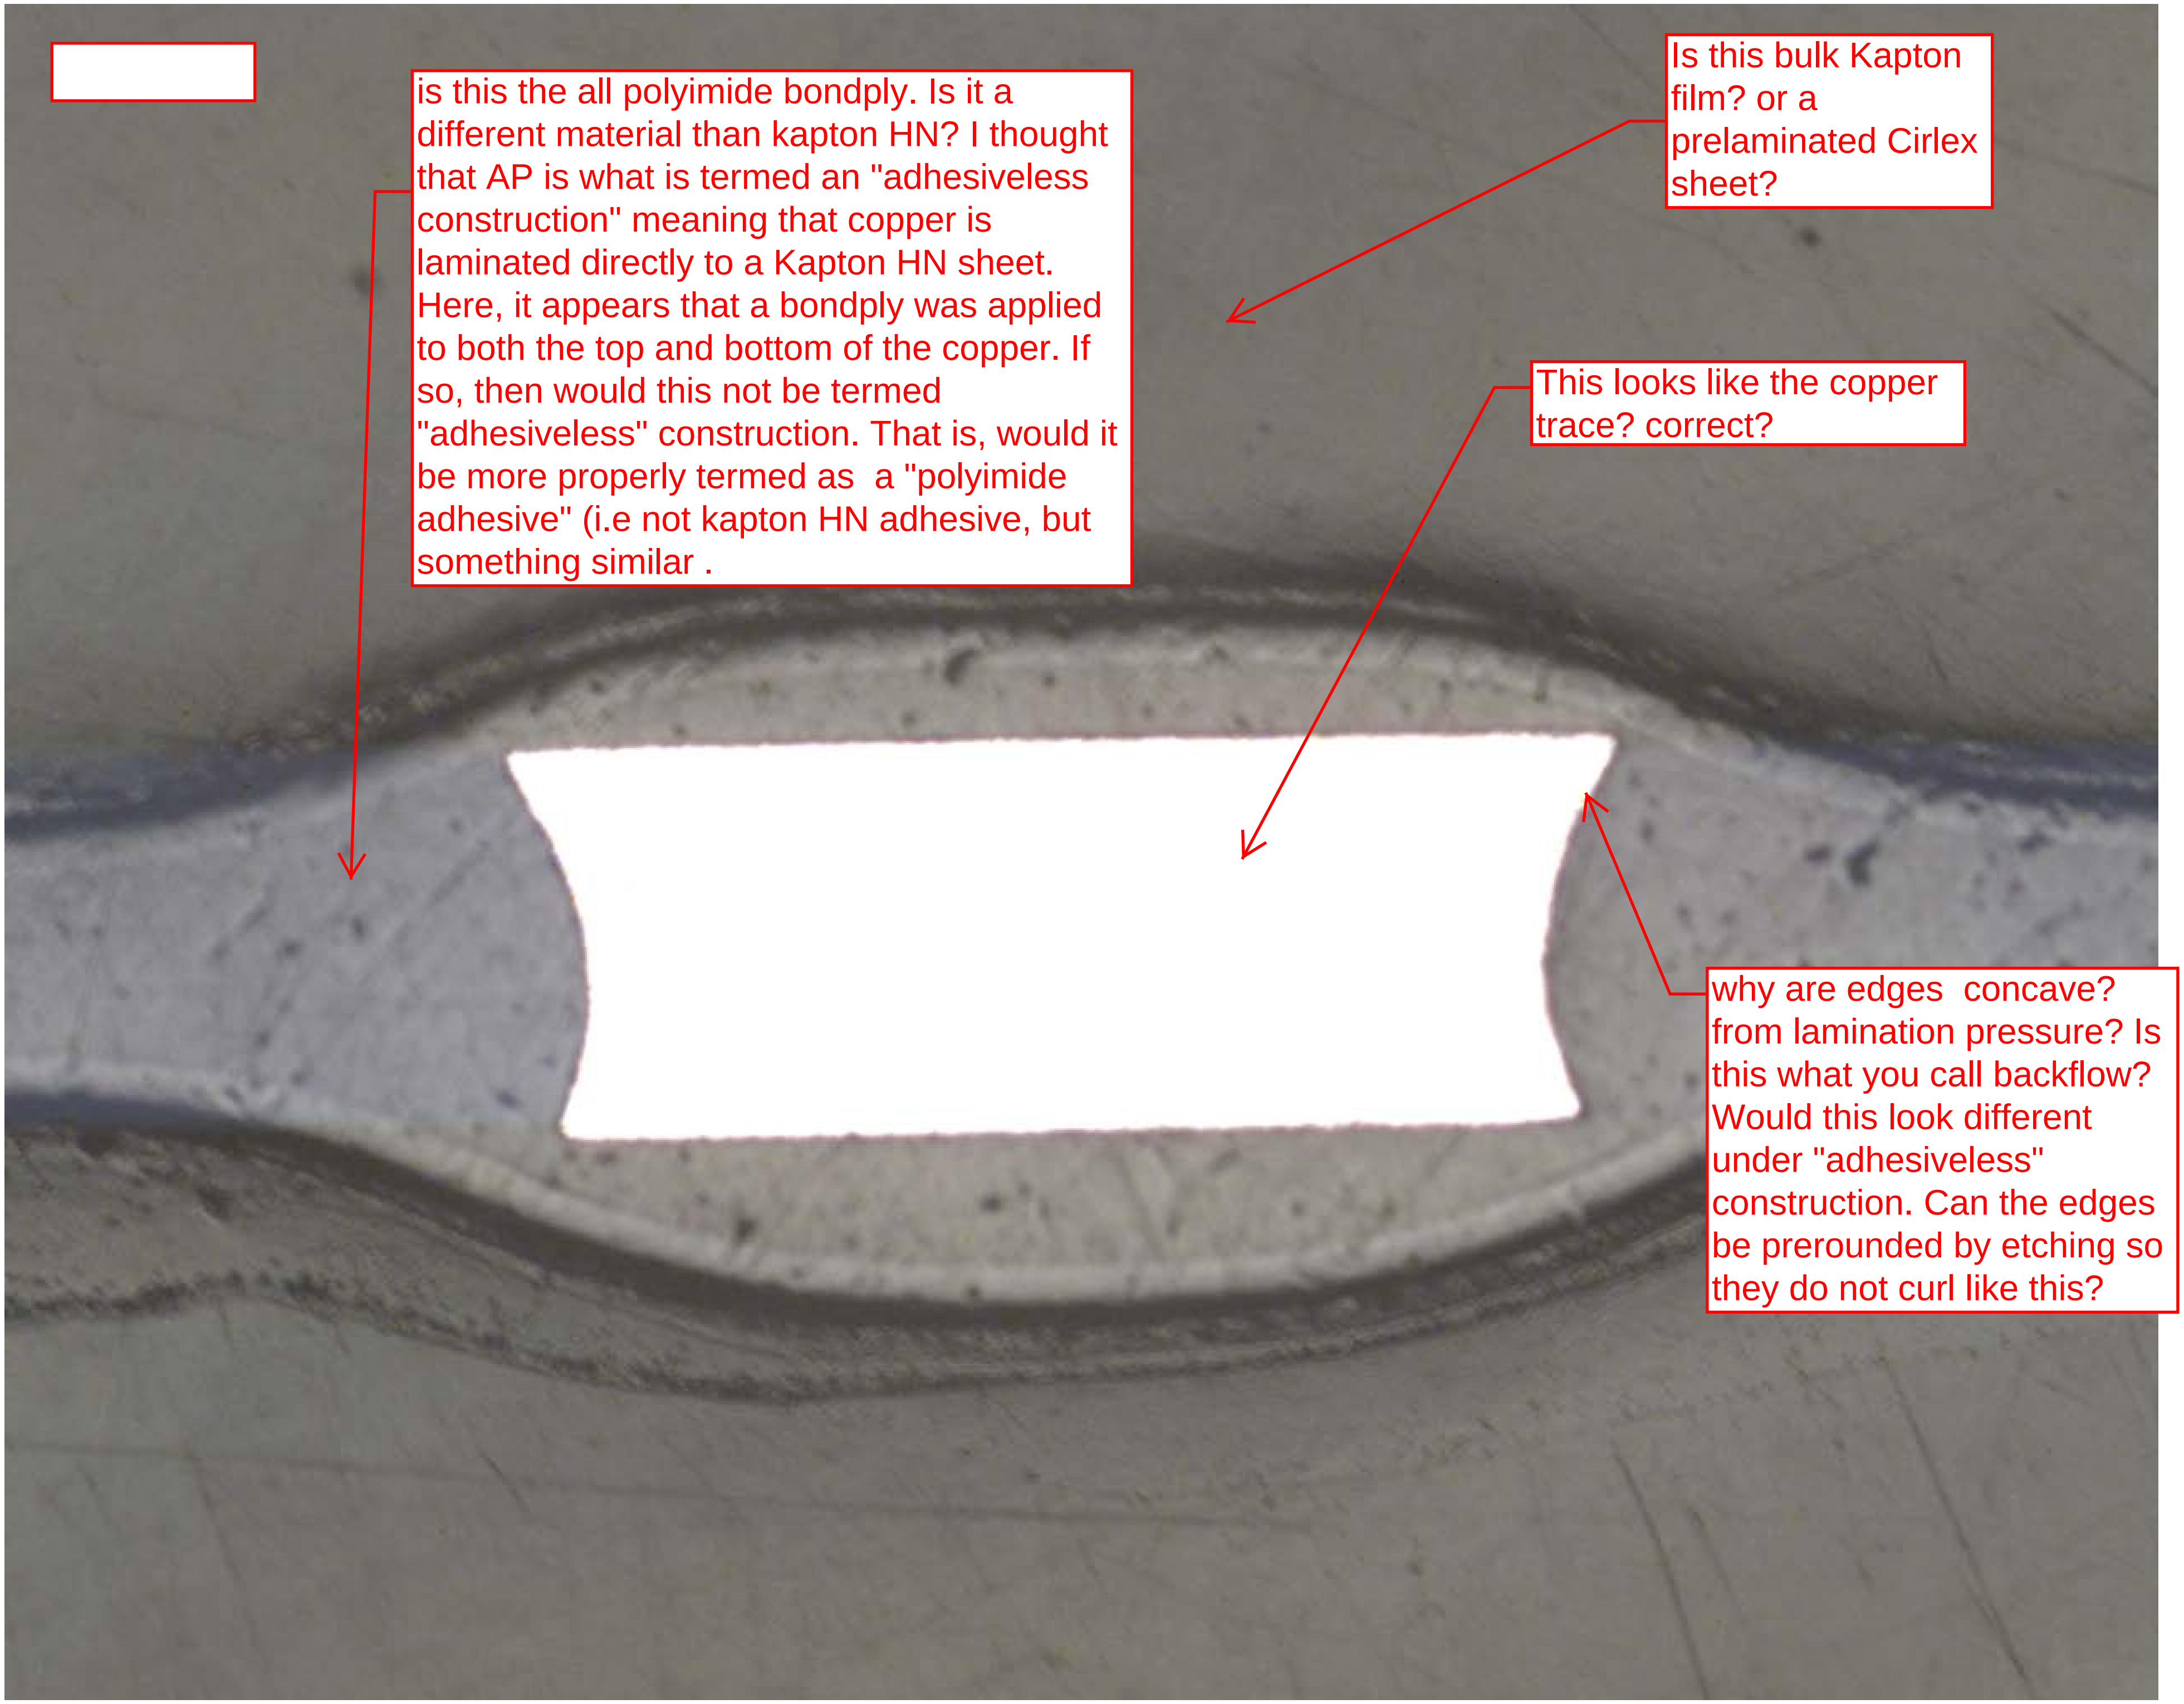
is this the all polyimide bondply. Is it a different material than kapton HN? I thought that AP is what is termed an "adhesiveless construction" meaning that copper is laminated directly to a Kapton HN sheet. Here, it appears that a bondply was applied to both the top and bottom of the copper. If so, then would this not be termed "adhesiveless" construction. That is, would it be more properly termed as  a "polyimide adhesive" (i.e not kapton HN adhesive, but something similar .

Is this bulk Kapton film? or a prelaminated Cirlex sheet?

This looks like the copper trace? correct?

why are edges  concave? from lamination pressure? Is this what you call backflow? Would this look different under "adhesiveless" construction. Can the edges be prerounded by etching so they do not curl like this?
